# 1987 - 1991 Corvette: Service Bulletin: 4L60 Low & Reverse Clutch New Plate Available

**Subject:** 4L60 LOW & REVERSE CLUTCH NEW WAVE PLATE IS AVAILABLE

**Model and Year:** 1987-91 CAPRICE, CAMARO, CORVETTE AND 1987-91 C/K, RN, S/T TRUCKS, G, M VANS AND 1990-91 L VAN WITH 4L60 AUTOMATIC TRANSMISSION

**Bulletin Number:** 91-186-7A - (01/29/1991)

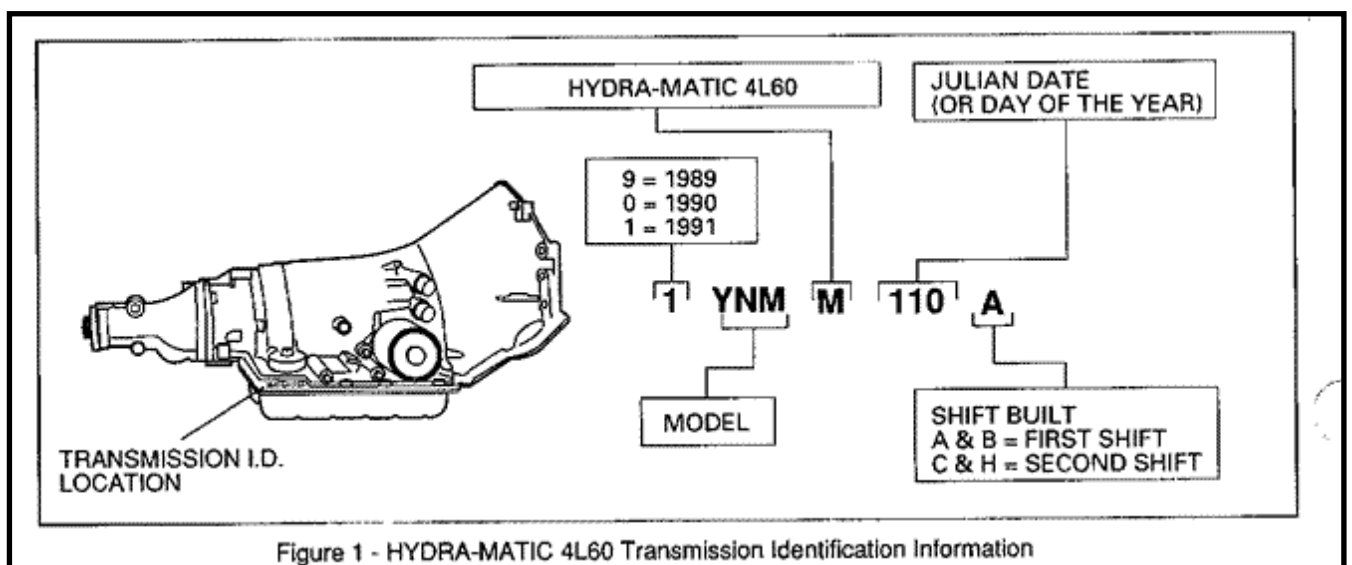
DATE OF PRODUCTION CHANGE: (Figure 1)

----- Beginning March 28,1990 (Julian Date 087), all HYDRA-MATIC 4L60 transmissions were built using the new low and reverse clutch wave plate.

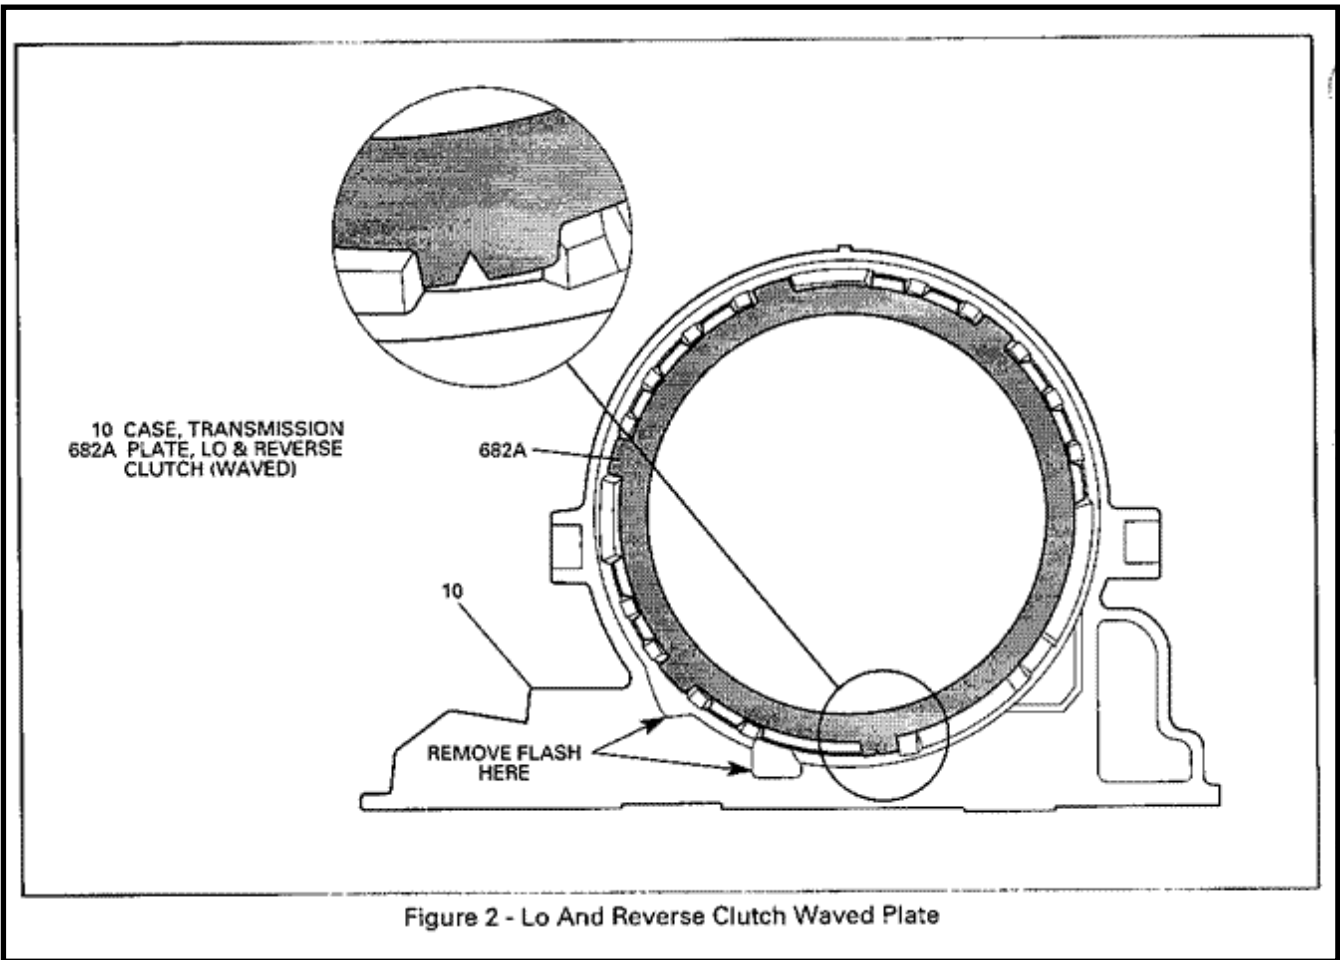
SERVICE INFORMATION: (Figure 2) ----- Low and Reverse Clutch failure can be caused by case casting flash interfering with clutch plate travel. A new wave plate is now available which will alleviate this condition. This new plate can be used to service any Hydra-matic 4L60 transmission produced after February 9, 1987 (Julian Date 040).

When installing the new wave plate, check for any case flash that may be present in the low and reverse grooves, and use a metal file to remove. See Figure 2 for case location information.
